**LONG CHIH INDUSTRIAL COMPANY LIMITED**  
101, Show Shan Road, Shinchuang City, Taipei Hsien, Taiwan, ROC  
Tel: 886-2-29068666 Fax: 886-2-2906-8669 E-mail: longchih@ms31.hinet.net

## **SAFETY RECALL NOTICE**

Long Chih -- trailer manufacturer has decided that all our trailers manufactured from September 1, 2005 to December 31, 2008 fail to conform to Federal Motor Vehicle Safety Standard No. 110. "Tire Selection and Rims." These trailers are missing the tire placard label which states the tire size, tire pressure, and maximum load information. The gross vehicle weight rate (GVWR) on the VIN plate on some of the trailers is incorrect and the GVWR and gross axle weight rate (GAWR) units should be specified in pounds on the VIN plate. Also, the owner's manual is missing the information to report suspected safety defects as required by Federal Regulation Title 49 CFR Part 575 "Consumer Information." A misprinted label could lead to improper vehicle loading specification or tire inflation which could result in a tire failure, increasing the risk of a crash.

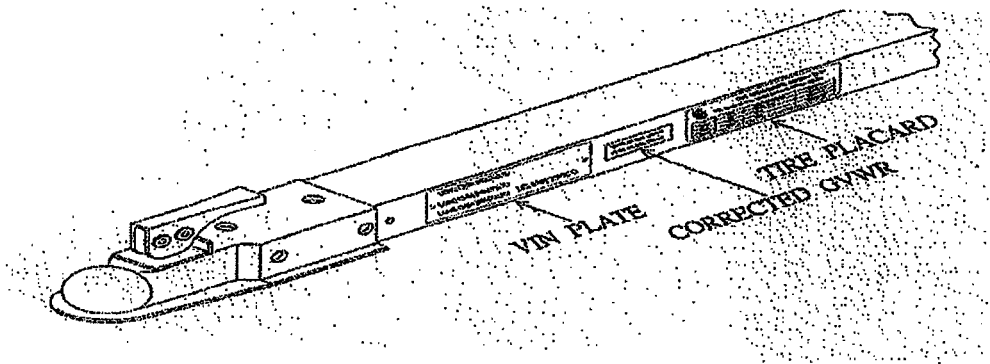
Enclosed with this letter is the correct tire placard label and GVWR label. Please affix these labels to the driver's side of the trailer tow bar near the VIN plate as shown below in this picture. Also enclosed is the "Reporting Safety Defects" statement as a part of owner's manual. Please read this statement and save it with

How to install the stickers?

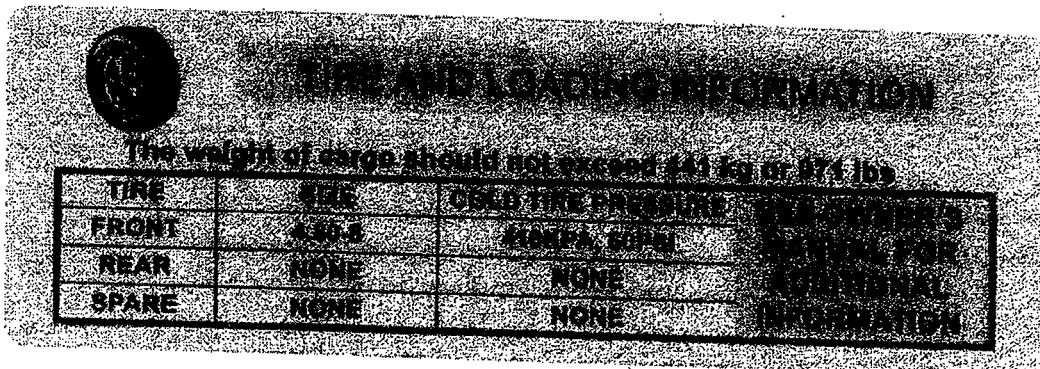
1. Clean the surface of the tow bar driver's side as on above diagram.
2. Please affix the provided corrected GVWR label first then tire placard on clean surface of tow bar.
